**REBUTTAL TESTIMONY OF RICHARD KUPREWICZ
EVALUATING PG&E'S PIPELINE SAFETY ENHANCEMENT
PLAN**

**CALIFORNIA PUBLIC UTILITIES COMMISSION
PIPELINE SAFETY RULEMAKING
R. 11-02-019**

**Submitted on behalf of
THE UTILITY REFORM NETWORK (TURN)**

February 28, 2012

Figure 1: Pressure Cycling, MAOP = 975 psig

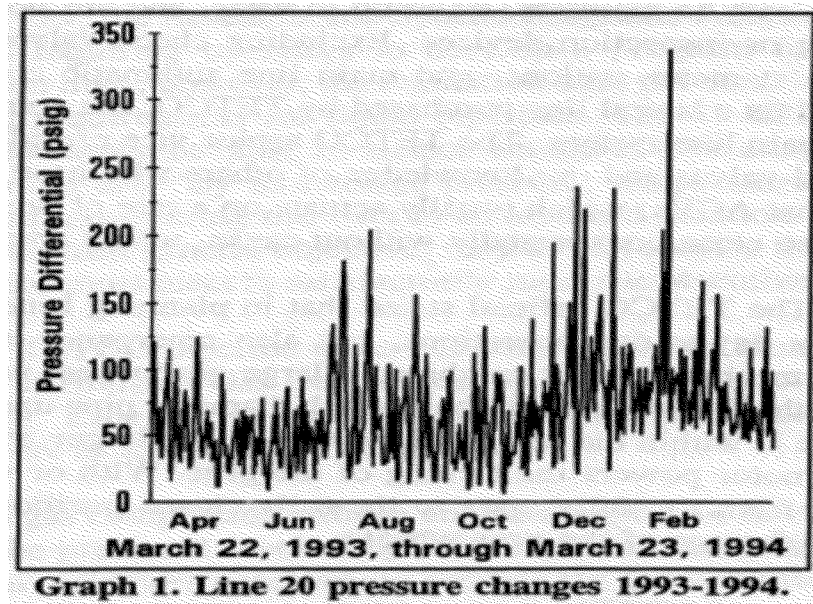
14 Low-pressure, low % SMYS, hydrotesting can leave very large imperfections in the
15 manufactured pipe seam welds that are much more susceptible to further growth to rupture
16 failure in a relatively short time from pressure cycling than the much smaller imperfections left
17 in high-pressure hydrotesting. This is especially true on many gas transmission pipelines that
18 undergo considerable variations in their operating pressure, which occurs on most gas
19 transmission pipelines. It is a myth that gas transmission pipelines do not pressure cycle. Figure
20 1 below is an example of a gas transmission pipeline pressure cycle spectrum (MAOP of 975

1 psig) in the public domain whose pipe ruptured from time -delayed damage many years after the
2 damage occurred.¹
